I am writing to request that you deny special permit Adams Street (189-193)/Quirk Court (19) - #137-18 for the reasons I shall set forth below.

Figure 1 (Original Filed Plan, 1 way access, exiting out into Quirk Court)

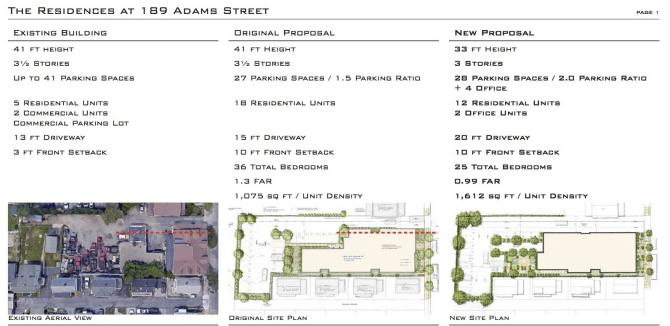
The most recent revised architectural plans are misleading. They reference the "Original Proposal", and the "New Proposal" (figure 2). The petitioner chose not reference the true original proposal, which proposed a one way system, existing out onto Quirk Court. See http://www.newtonma.gov/civicax/filebank/documents/87977 (figure 1). The very same proposal proposed 23 parking spaces, and not the 27 as offered as the "Original" above.

Figure 4 (Most Recent Plan)

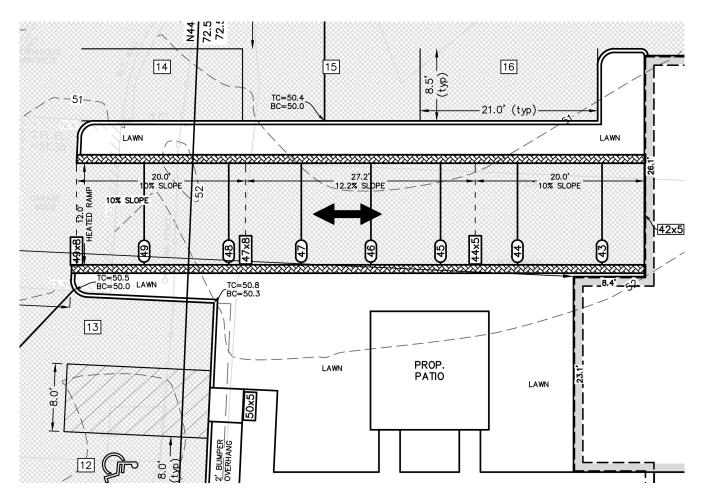
The most recent proposal can be found at http://www.newtonma.gov/civicax/filebank/documents/91547 or figure 4.

Whilst I believe the most recent proposal has addressed concerns about the driveway access, it did not address the setback issues on Quirk Court. The majority of the building on that side still retains a 5 foot side setback, despite being granted relief with a 3rd floor. Essentially this means that the new structure and existing buildings on Quirk st will be separated by approximately 9, 10, and 15 feet..
